TO: Freightliner Dealer Principals, General Managers, Sales Managers, Service Managers, Parts Managers	FROM: Anthony Washington, Department Manager, Regulations and Certifications
RE: Recall Campaign Notification Model 907 (Sprinter) Model Years 2019 Screw Connection Hood Catch	DATE: October 17, 2019

Campaign No. :	Campaign Desc. :	Screw Connection Hood Catch
2019100006	VS3HAUBOSS	
<p>This is to notify you of the upcoming Recall Campaign concerning the screw connection on the upper hood catch on approximately 3,817 MY19 Mercedes-Benz Sprinter vans. The recall campaign will be visible on the www.safercar.gov website and may generate questions from customers. All affected VINs will be flagged as "Open" in VMI on October 18, 2019.</p>		
Background		
Issue	Daimler AG ("DAG"), the manufacturer of Freightliner Sprinter vans, has determined that, the screw connection on the upper hood catch of certain Freightliner Sprinter vehicles (VS30; Platforms 907) may not have been carried out according to specification. Depending on vehicle speed, wind resistance, aerodynamic drag and factors such as vehicle loading and road conditions, the hood could open while the vehicle is being operated. If t

D88.40-1130-06

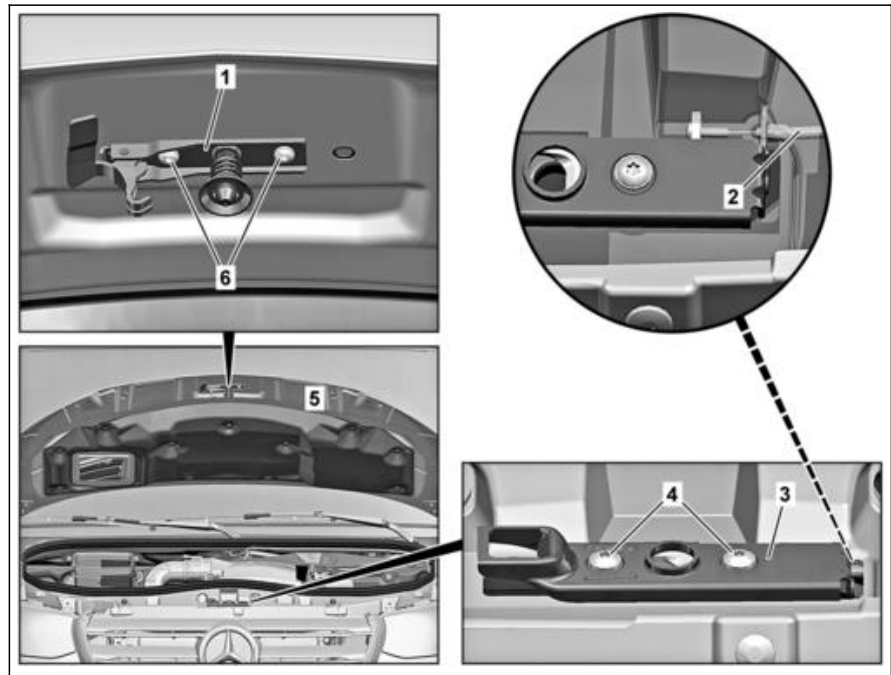
- 1 Hood catch upper section
6 Bolts

2	Check whether the screws (6) are present.	If a screw (6) are not present, ↓ screw in missing screw (6) subsequently by hand.	
Retighten Screws			
3	Retighten screws (6).	Bolt, upper section of hood catch to hood	BA88.40-N-1003-01TS

Number	Designation	Model 907
BA88.40-N-1003-01TS	Bolt, upper section of hood catch	8Nm
